FLIGHT READINESS STATEMENT
STS-72/ET-75 AND STS-75/ET-76
Δ EXTERNAL TANK PROJECT REVIEW

Delta ET Project

STS-72/ET-75
STS-75/ET-76
Flight Readiness Review

Thrust Panel Buttstrap Fastener Change (B01944) 11

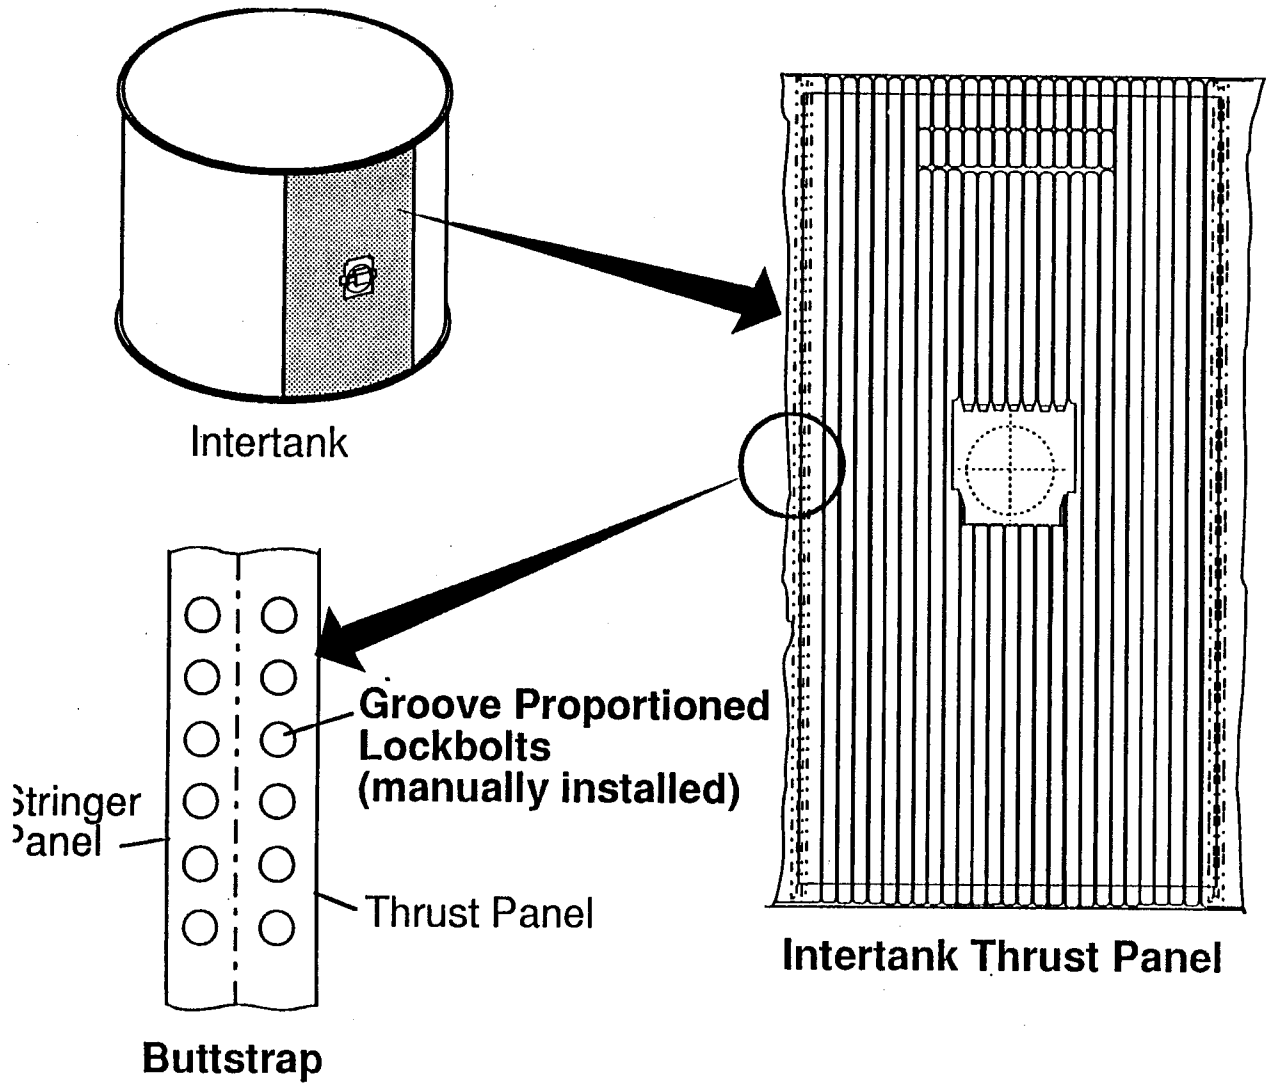
- Hardware
  - Change Hi-Set rivets to Huck Groove Proportioned (GP) lockbolts on thrust panel buttstraps
- Requirements
  - Revise MMC-ET-SE16 to include GP lockbolts
  - Create new STP to install GP lockbolts

- Hi-Set rivets produced highest number of non-conformances of all fasteners on ET
  - Installation of Hi-Set rivets are very labor intensive and operator dependent
  - Rework of Hi-Set rivets requires drilling and repair sleeve installation
- GP lockbolts enhance installation process while retaining tensile strength

- Tests - MIL-HDBK-5 testing by supplier (Huck)
- Stress analysis, FS = 1.47 (unchanged)

Aluminum Alloy Forgings Revision (B01976)

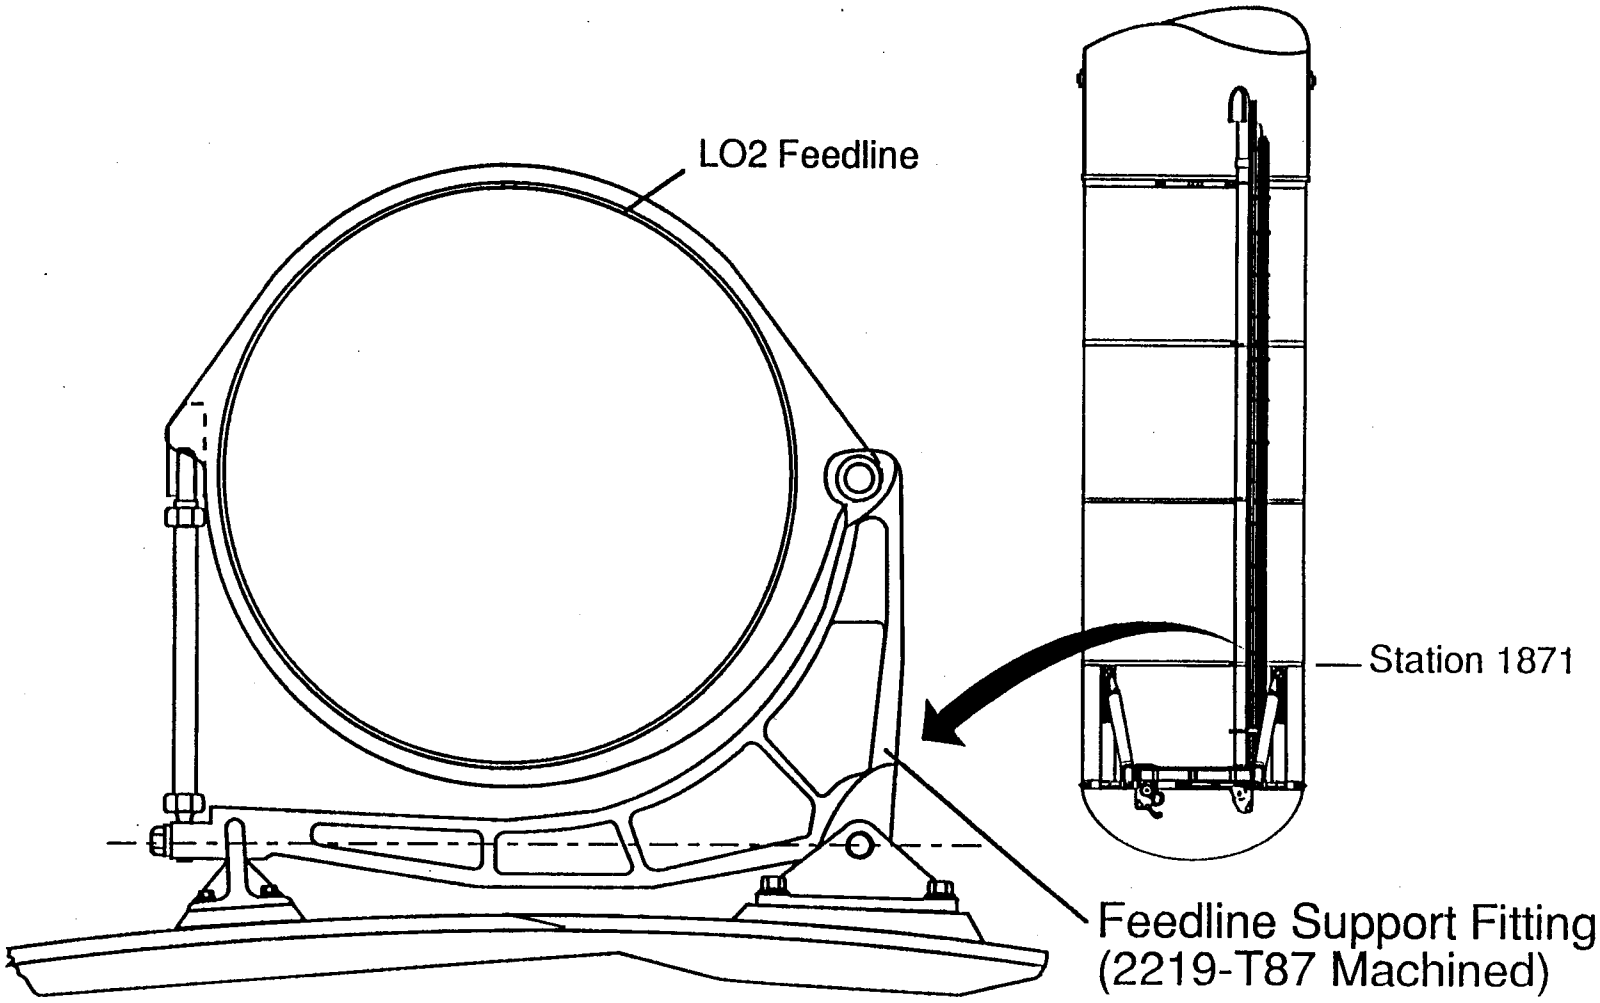
- Hardware — Replaced 2219-T6 forging for LO2 feedline yoke support fitting at Station 1871 with a machined 2219-T87 fitting
- Requirements
  - Revised STM 5163 to lower ultimate and yield strength requirements on forged fittings
  - Revised CIL to reflect hardware change

- History of 2219-T6 forgings failing to meet the specification's minimum mechanical properties
- Test data indicated original strength values were set too high
  - New spec requirements reflect vendor data base on 900 test specimen
  - Revised spec to lower strength requirements
    - Resulted in reduced margin of safety on 23 forgings
  - LO2 feedline yoke support fitting at Station 1871 changed to machined fitting providing positive margin

- Stress analysis
  - Station 1871 machined yoke support fitting
    - FS = 1.65, minimum
    - Required FS = 1.36
  - Remaining 22 forgings
    - FS = 1.31, minimum (thrust strut end fitting)
    - Required FS = 1.27
- Verification tests
- Similarity to previously built hardware
  - 2219-T87 fitting also installed at Stations 1129 and 1377
